GRANDVIEW CONDOMINIUM COMMUNITY

PROJECT: 12023-0022/PS/P0203-0010
REVISION: Revision #7
RECEIVED: 8/14/2026
PLANNING & ECONOMIC DEVELOPMENT DEPARTMENT

**Subject: Grandview Development along Auburn Road,
Site Plan Review #7
Plans dated July 29, 2026
ASTI File No. P25-0125.33**

SITE PLAN .pdf Markup Summary

WETLAND

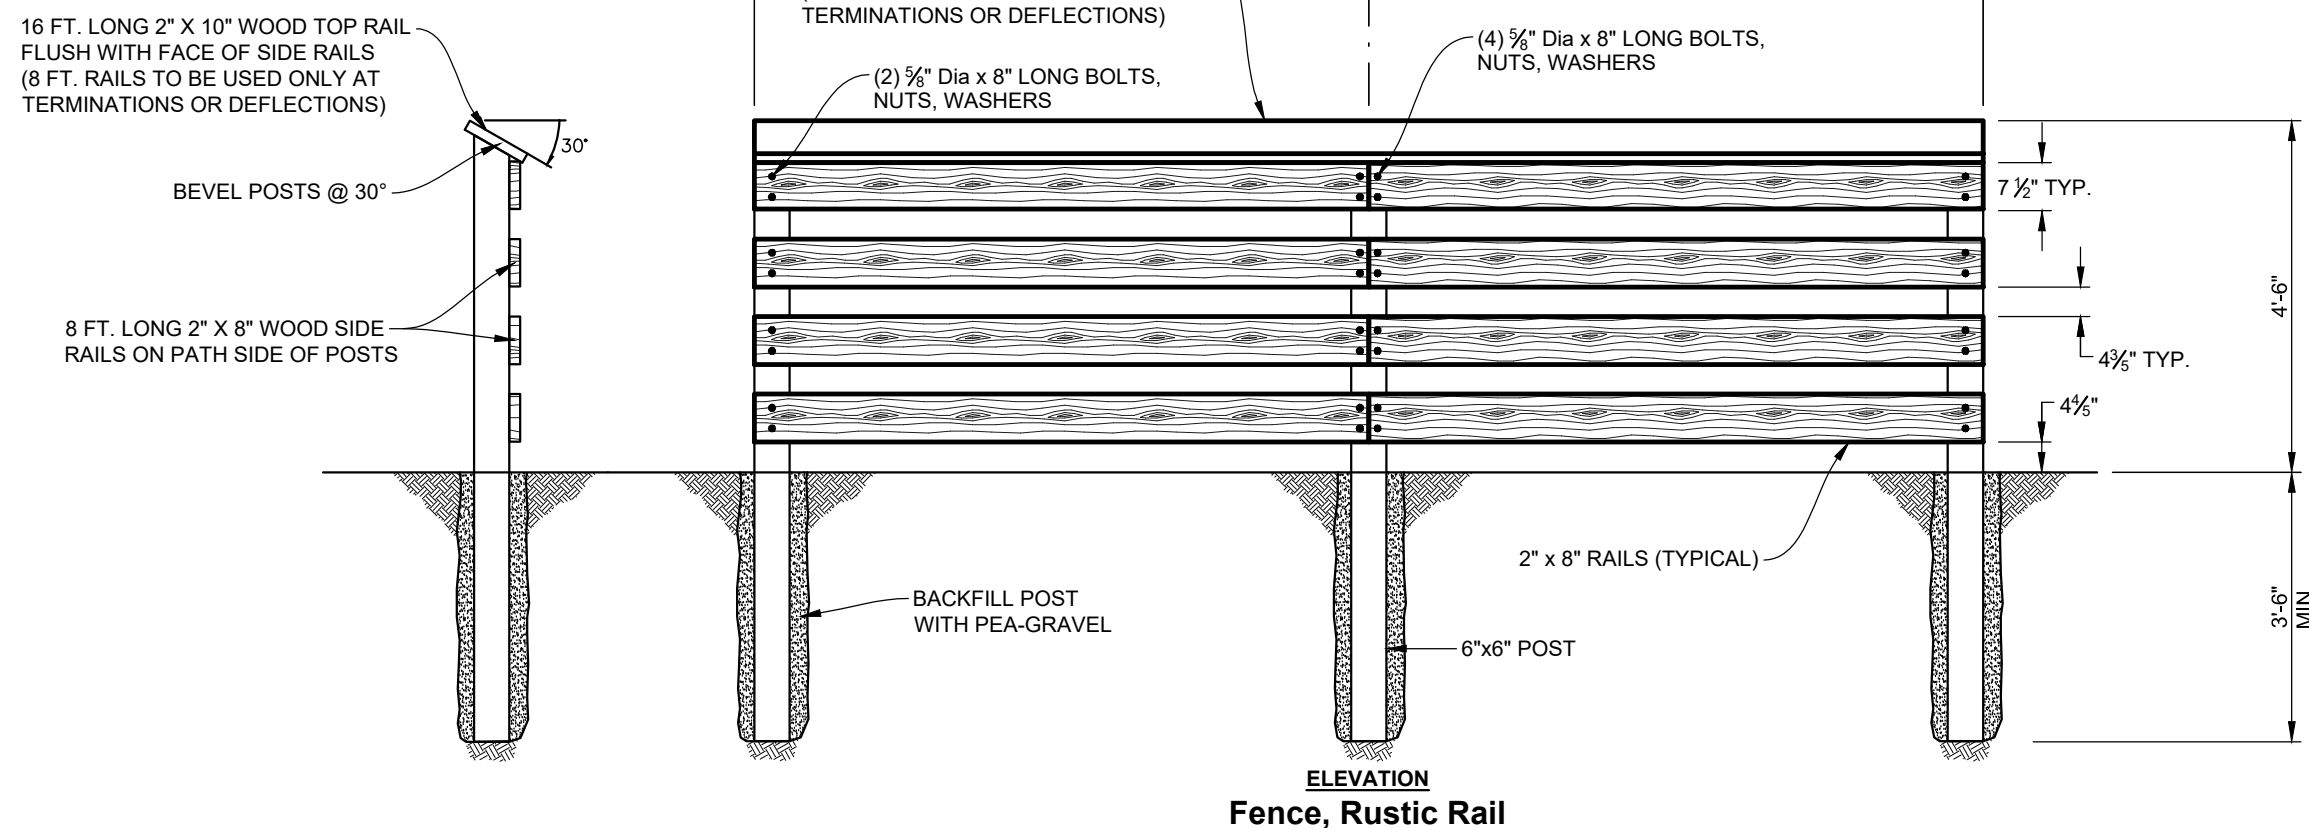
Plans reviewed by the Planning Commission with additional wetland impacts

15,822 square feet of permanent wetland impact - reduced from 18,267 square feet from site plans reviewed by Planning Commission

336 linear feet of natural features setback modification - unchanged from site plans reviewed by Planning Commission

- b. The table on Sheet 2A, as referenced above, indicates 15,822 square feet (0.36 acres) of Wetland B will occur from the construction of the northern portion of Sage Lane and from grading activities associated with the construction of Lots 9 and 10; this represents a 0.06 acre decrease in impacts

- a. Sheet 2A of the Current Plans shows Natural Features Setback areas associated with Wetland B accurately based on the updated wetland delineation. Since Wetland A is not regulated by the City, Natural Features Setback areas are not required to be shown for this wetland.

- c. Sheet 2A of the Current Plans indicates 336 linear feet of permanent Natural Features Setback impacts associated with Wetland B will occur from grading activities associated with the construction of Sage Lane and grading activities associated with the construction of Lots 9 and 10 in the northern portion of the site. Please note that during previous reviews, ASTI deemed the construction of Sage Lane of greater public good than the preservation of the moderate quality Natural Features Setback in this area; Sage Lane is already partially platted and, thereby, a prudent expectation of developing this roadway exists. This remains the case. ASTI recommends the City allow for these impacts as shown on the Current Plans.

UTILITY PLAN

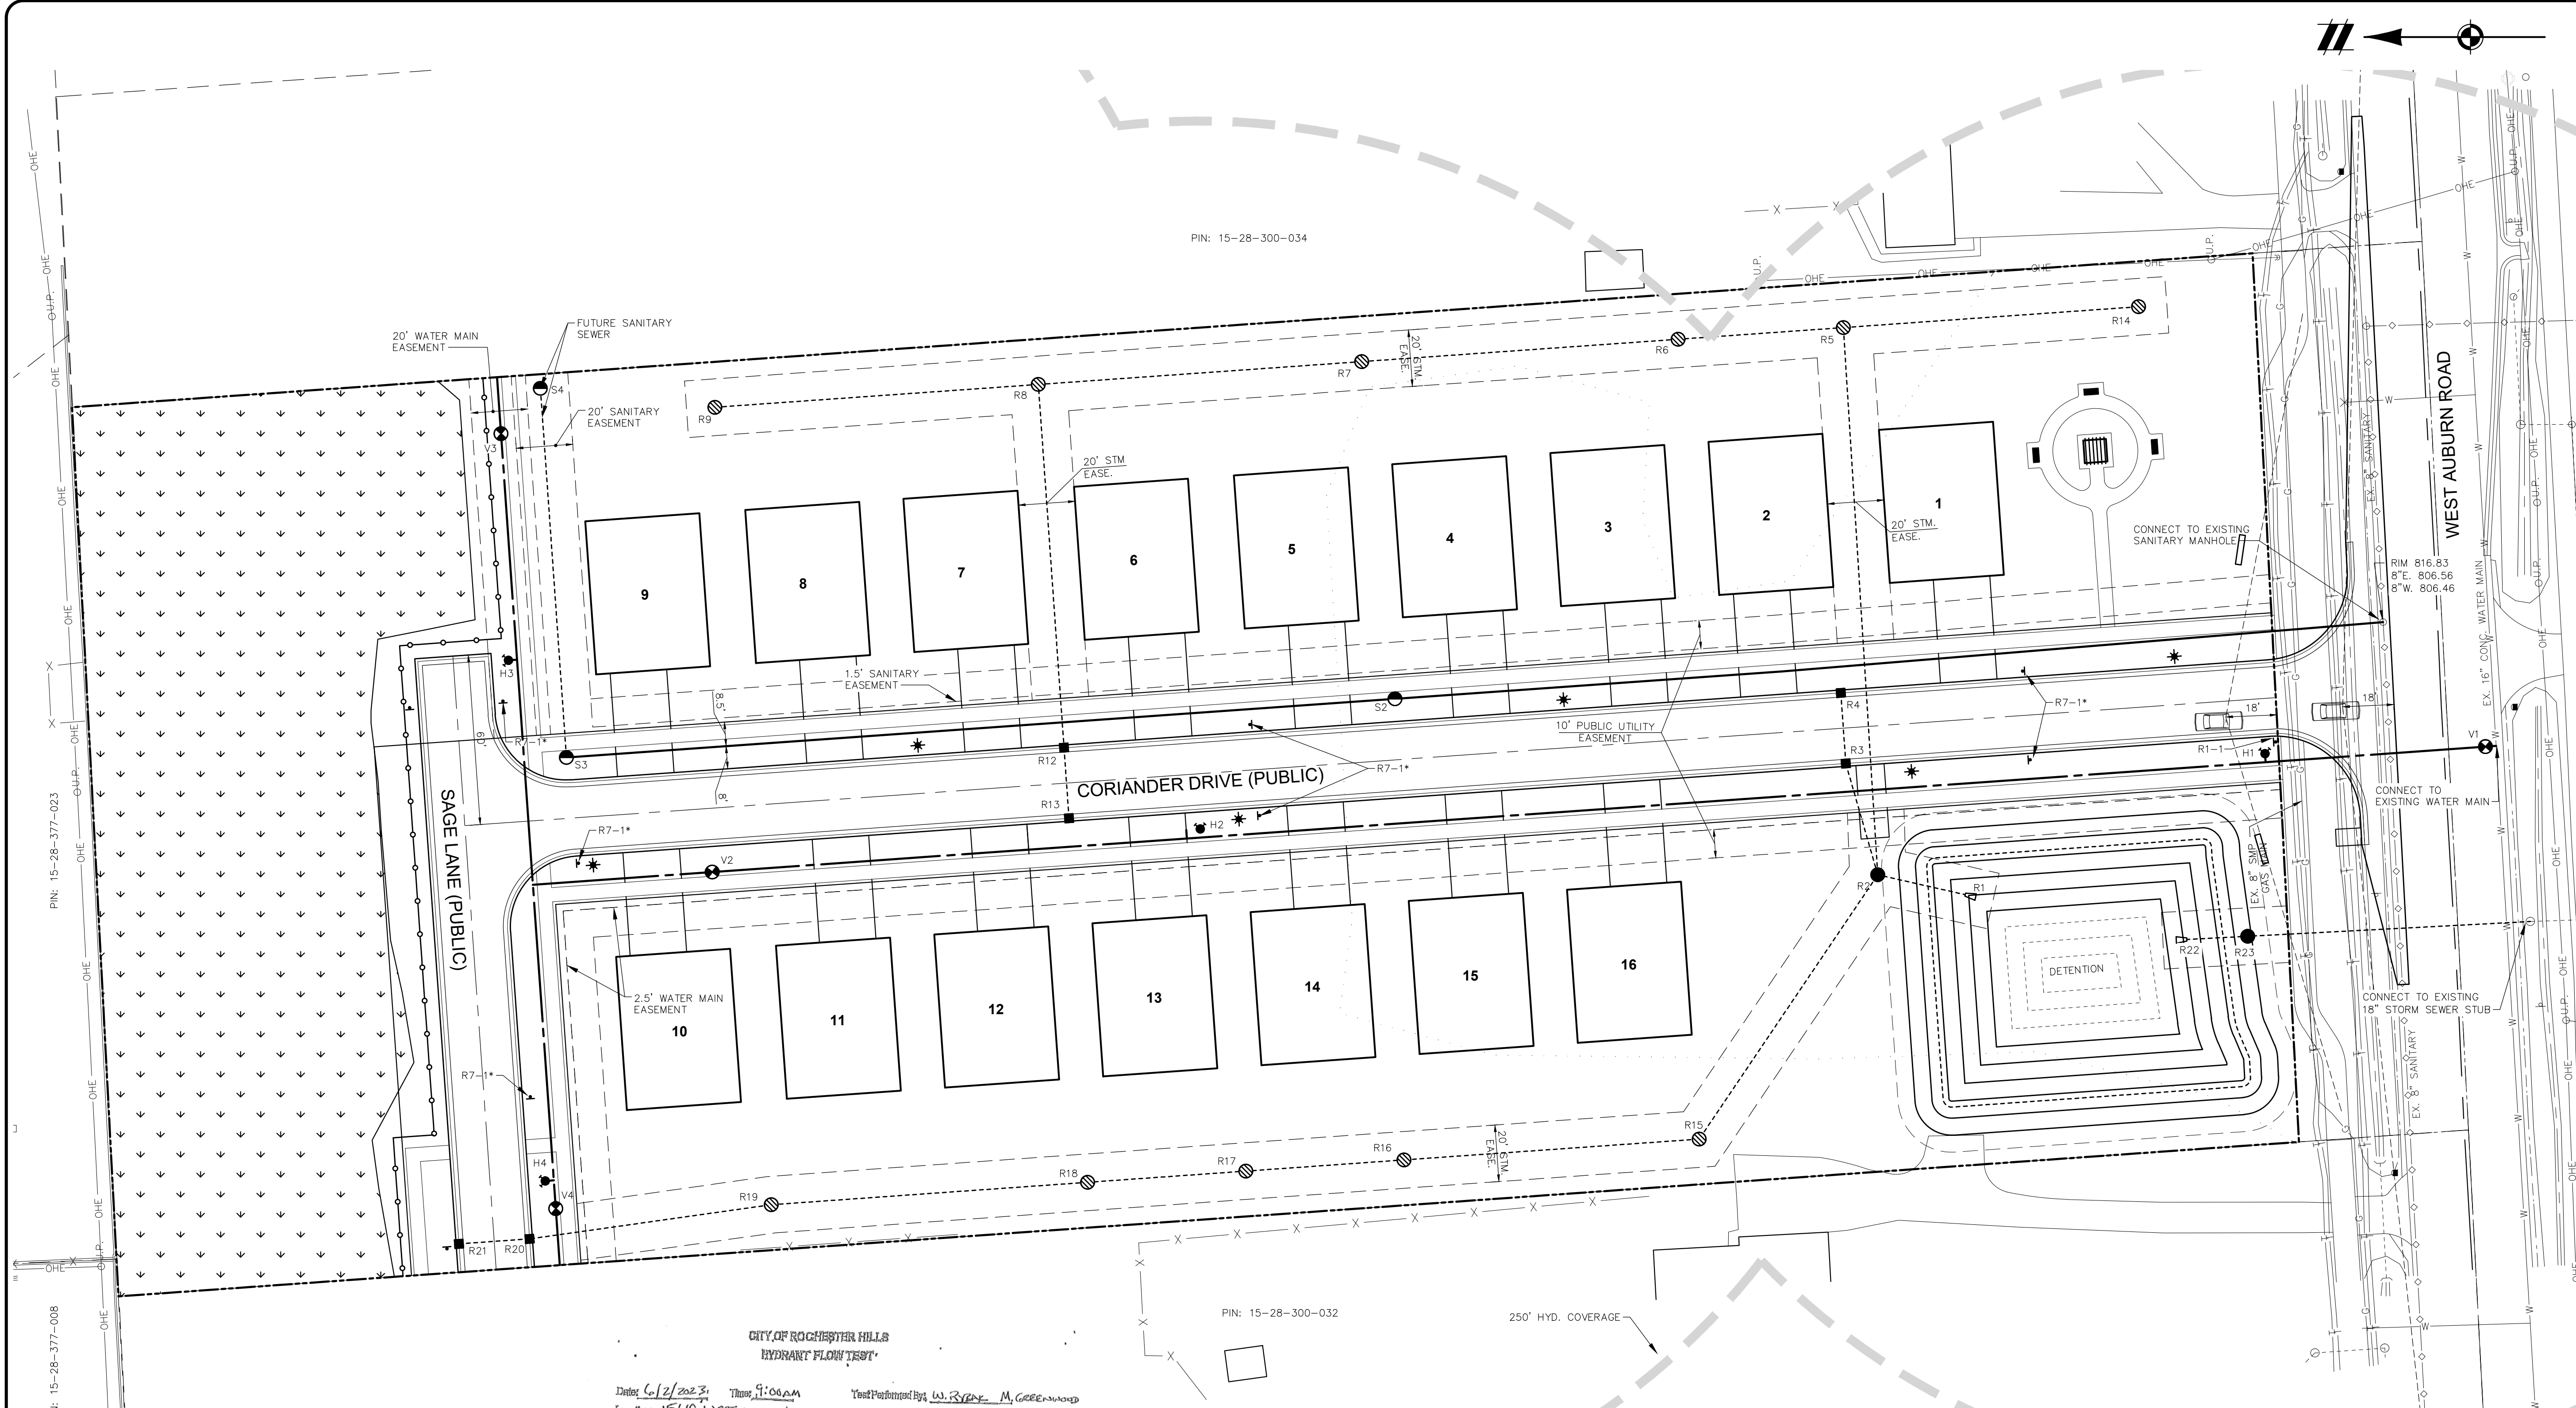
Revise to 8" Ex.

Revise to 8"

CONCEPTUAL LANDSCAPE PLAN

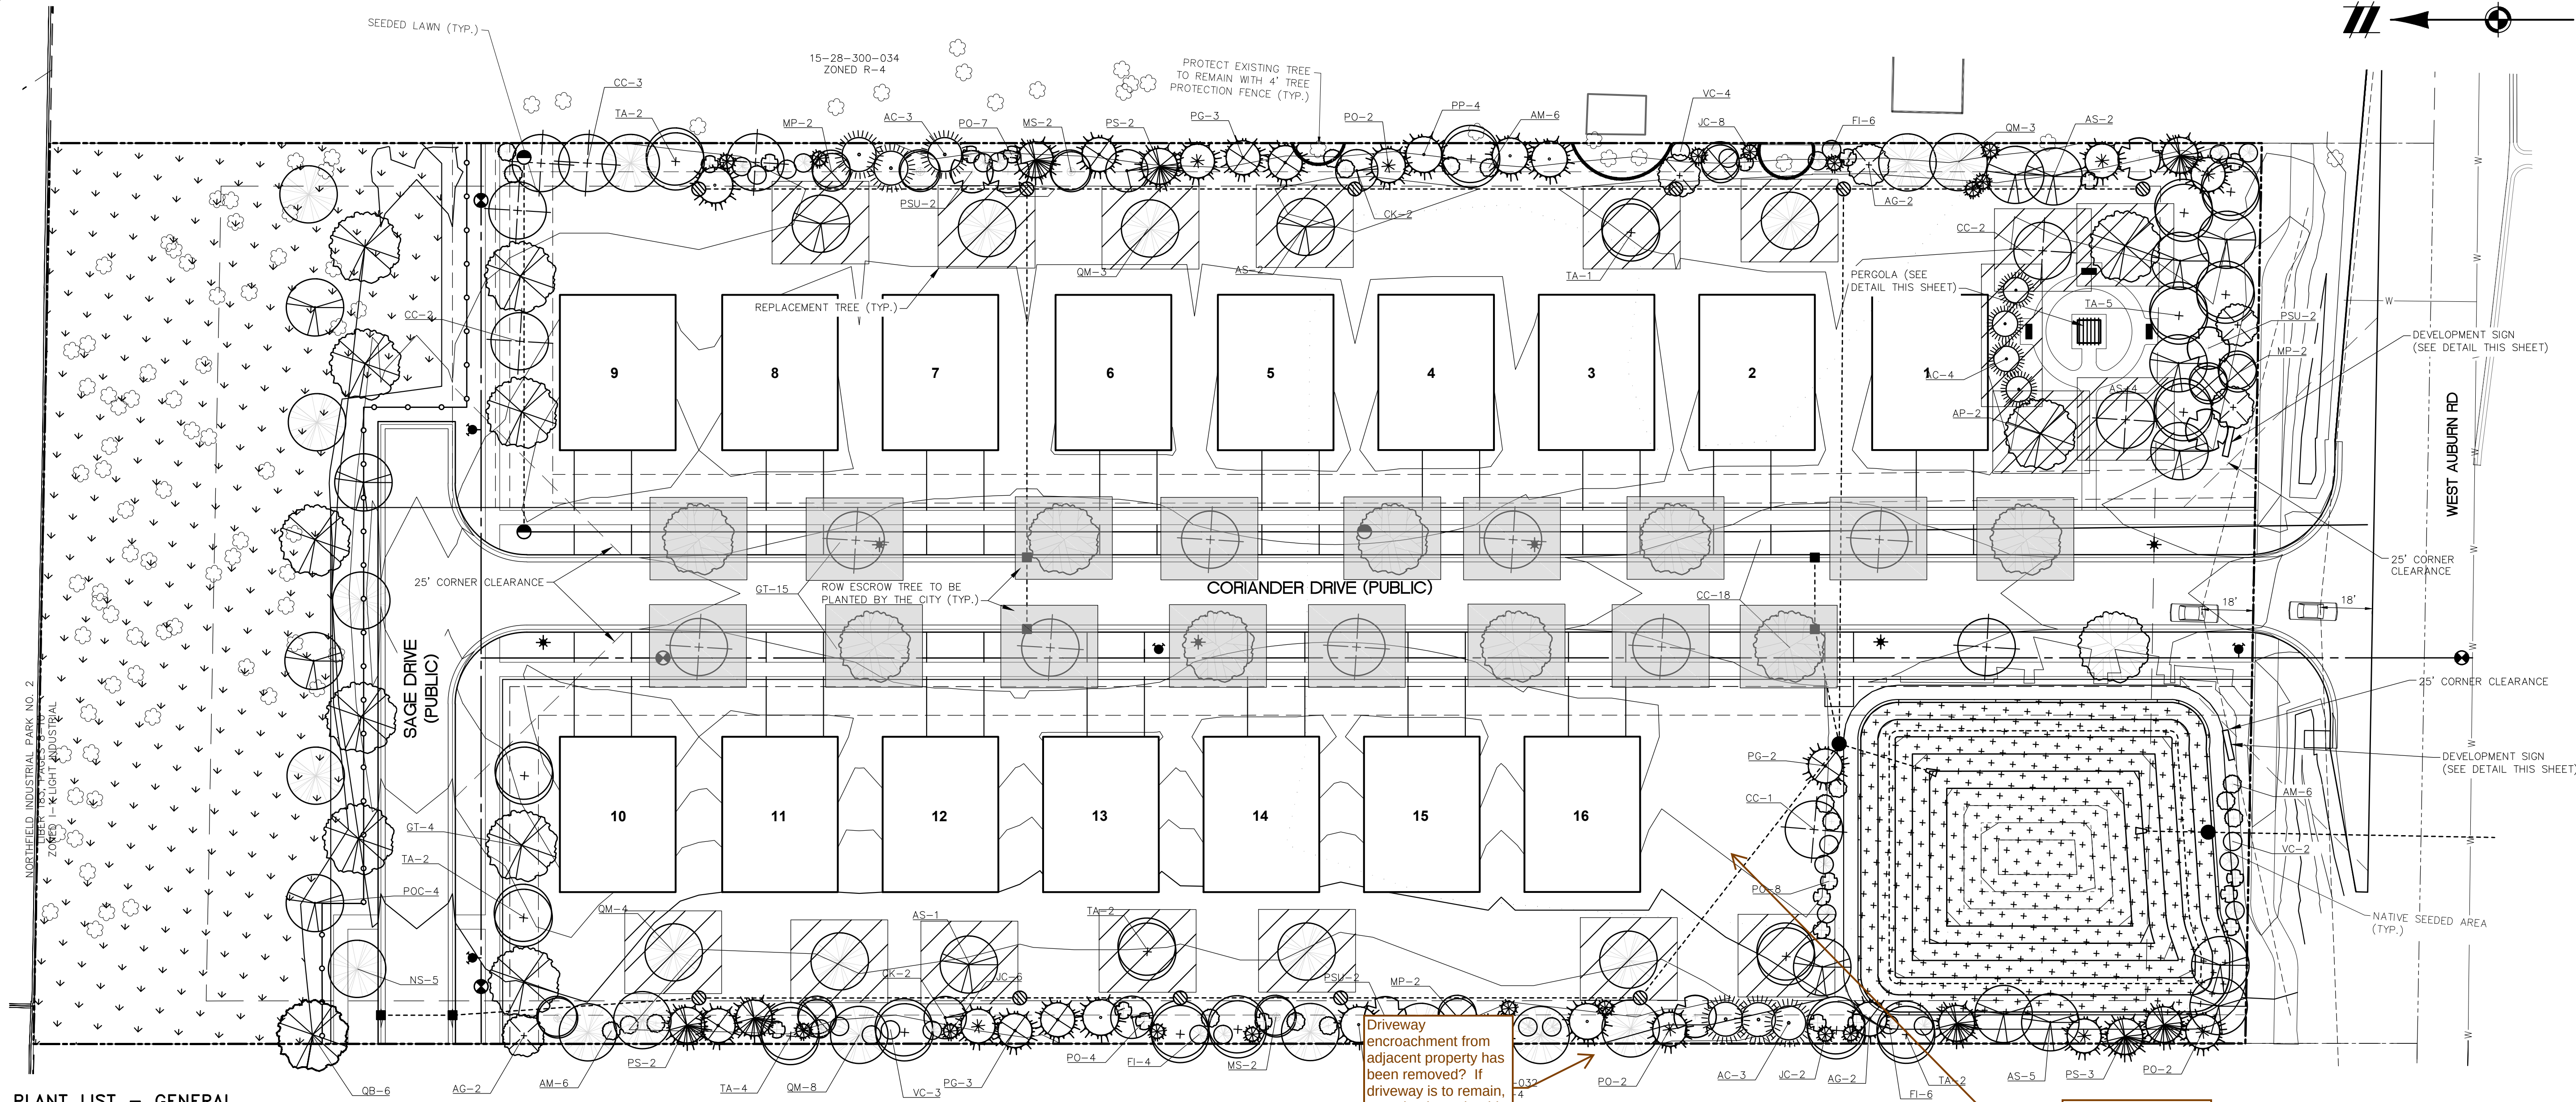
these numbers do not match. Sheet 3 - says 136 replacement needed. Update tables.

Plant List table on left shows 127 in tree fund + 21 planted = 148

Landscape requirement table on left shows 21 trees planted + 118 into tree fund = 139
Confirm correct number in plantings/ tree fund.

Additional trees should be planted in these open areas to reduce overall number of trees being paid into tree fund.
